UNITED STATES NUCLEAR REGULATORY COMMISSIONTENNESSEE VALLEY AUTHORITYAVAILABILITY OF SAFETY EVALUATION REPORT SUPPLEMENTRELATED TO THE OPERATION OFWATTS BAR NUCLEAR PLANT, UNITS 1 AND 2DOCKET NOS. 50-390 AND 50-391

ISSUANCE OF SAFETY EVALUATION REPORT,
SUPPLEMENT 18.

Safety Evaluation Report

related to the operation of
Watts Bar Nuclear Plant,
Units 1 and 2

Figure 1

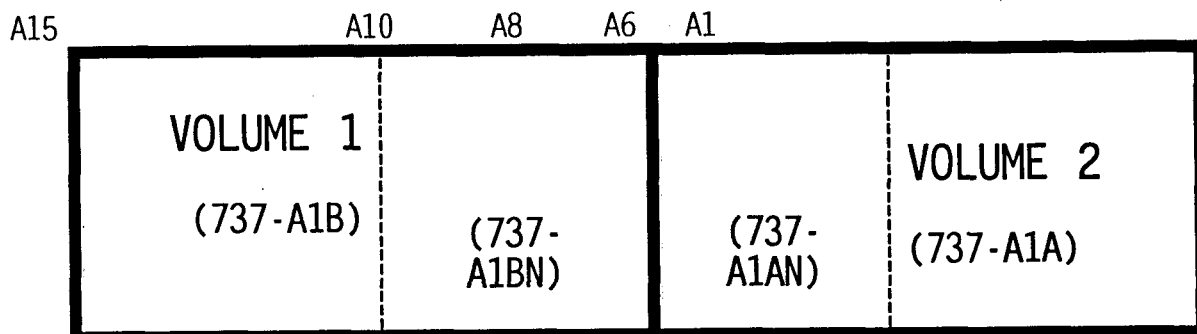
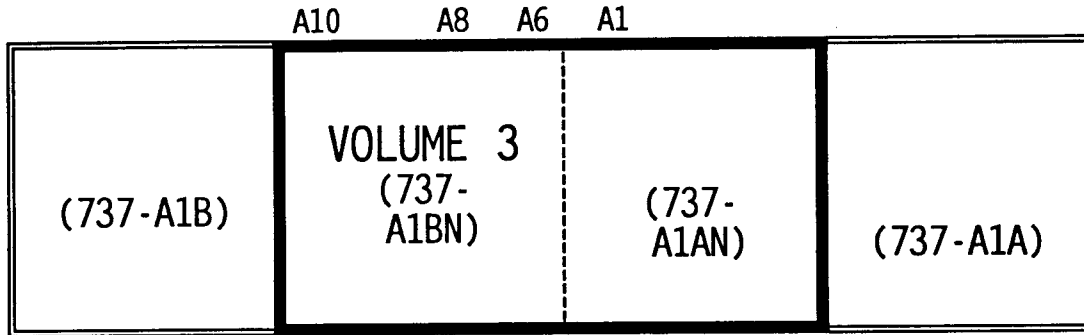
- *Sections of Large General Areas* - AVs consisting of sections of large general areas are separated from each other by "buffer zones." These buffer zones are wider than 20 feet. In large general areas where buffer zones are used that include intervening combustibles, enhanced automatic suppression and detection systems are installed in the large general area (refer to Section 6.4, "Deviation - Intervening Combustibles"). If redundant safe-shutdown cables are located in the AV, one train is selected to be protected by an electrical raceway fire barrier system. The electrical raceway fire barrier system is applied throughout the AV (i.e., from AV boundary to AV boundary). An example of this type of AV is shown in Figures 1 and 2, below.

For example, elevation 737 ft 0 in. of the auxiliary building was subdivided into smaller sections to facilitate the fire safe-shutdown analysis. First, as shown in Figure 1, the 737 ft 0 in. elevation was split into two main AVs at column line A8. Example Volume 1 covers the area between column lines A1 to A8 and example Volume 2 covers the area between column lines A8 to A15. Each of these AVs includes a >20-foot buffer zone (737-A1BN and 737-A1AN) which forms the interface between the two volumes. This interface forms a third AV (shown in Figure 2) and consists of the area between column lines A6 to A10 and is approximately 42 feet wide.

The applicant's evaluation process results in an overlap area of more than 20 feet where both trains of safe-shutdown equipment cables are protected. For example, if Train A cables were selected to be protected throughout Volume 3, both trains of safe-shutdown equipment cables would be protected in the Volume 2 buffer zone (column lines A-6 to A-8) because Train B cables are protected throughout Volume 2.

Figure 3

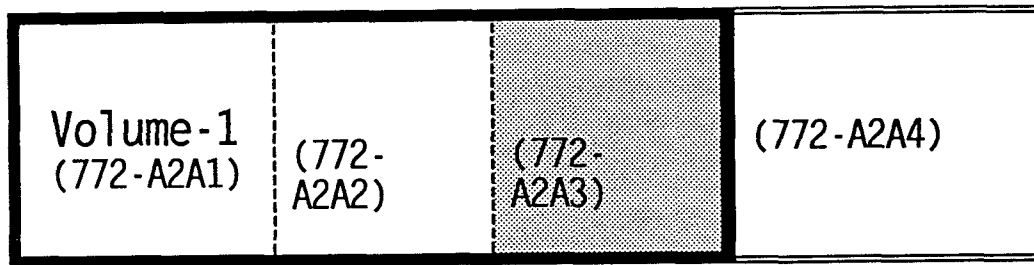
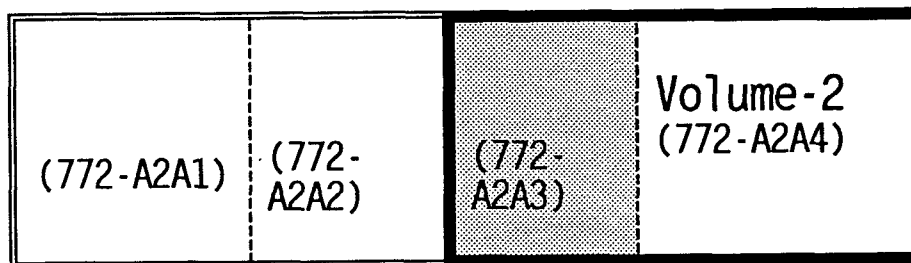
- *Sections of Large Rooms* - For AVs that consist of large room sections separated by an overlap region that is greater than 20 feet, the overlap region is considered to be part of both AVs. If the overlap region contains intervening combustibles, enhanced automatic suppression and detection systems are installed in the large room (refer to Section 6.4, "Deviation - Intervening Combustibles," for additional information). If redundant safe-shutdown cables are located in the AV, they are protected by an electrical raceway fire barrier system throughout the AV (i.e., from AV boundary to AV boundary). An example of this type of AV is shown in Figures 3 and 4, below.

Room 772-A2 (480-V board room 1B) is a large room subdivided into two AVs to facilitate analysis (Volume 1 and Volume 2). As shown in Figure 3 above, Volume 1 consists of room subdivision sections A2A1, A2A2, and A2A3, and as shown in Figure 4, Volume 2 consists of room subdivision sections A2A3 and A2A4. Section A2A3 is the overlap area that is part of both AVs. This overlap area was selected to provide a separation distance greater than 20 feet between the adjoining AVs.
